SERVICE BULLETIN

TITLE: FLIGHT CONTROLS - INSTALL FLAP INSPECTION ACCESS PANELS ON CERTAIN AERO CENTER PRODUCTS

This Service Bulletin provides instructions to add inspection access to flap skins on Aero Center products.

Figure 1

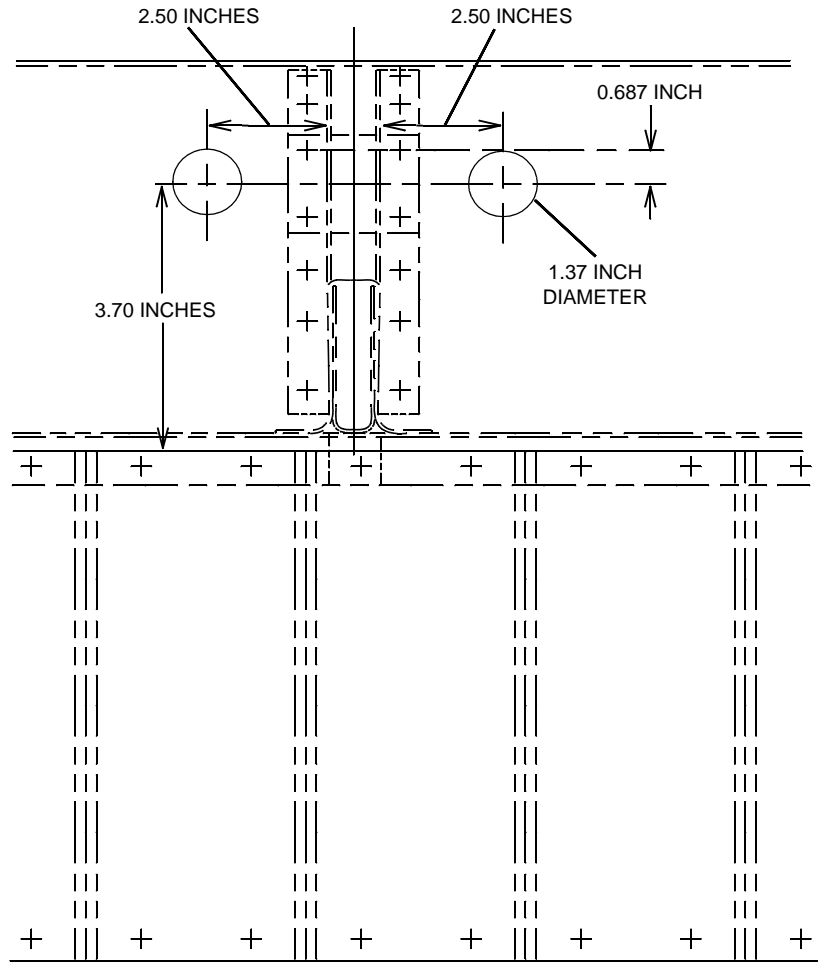
- (2) Remove flaps. For Duchess airplanes, refer to Maintenance Manual Chapter 27-50-00; for Musketeer, Sport, Sundowner and Sierra airplanes, refer to Beechcraft Shop Manual, Section 3-21.
- (3) Pull and collar flap circuit breaker (if applicable) and install warning placards against reconnecting power.
- (4) Locate the areas on top of flaps where inspection holes are to be added on both sides of flap hinges. Refer to Figure 1.
 - (a) Duchess 76 requires six (6) holes in each flap.
 - (b) Musketeer, Sport, Sundowner and Sierra require four (4) holes in each flap.
- (5) Carefully lay out hole locations and drill the 1.375-inch holes.

- (12) Install patch plates P/N 132641-5G on all inspection holes created in Step (4) of this service bulletin.
- (13) Install flaps on airplane. For Duchess airplanes, refer to Maintenance Manual Chapter 27-50-00; for Musketeer, Sport, Sundowner and Sierra airplanes, refer to Beechcraft Shop Manual, Section 3-21.
- (14) Reset flap circuit breaker if previously opened and remove warning placards.
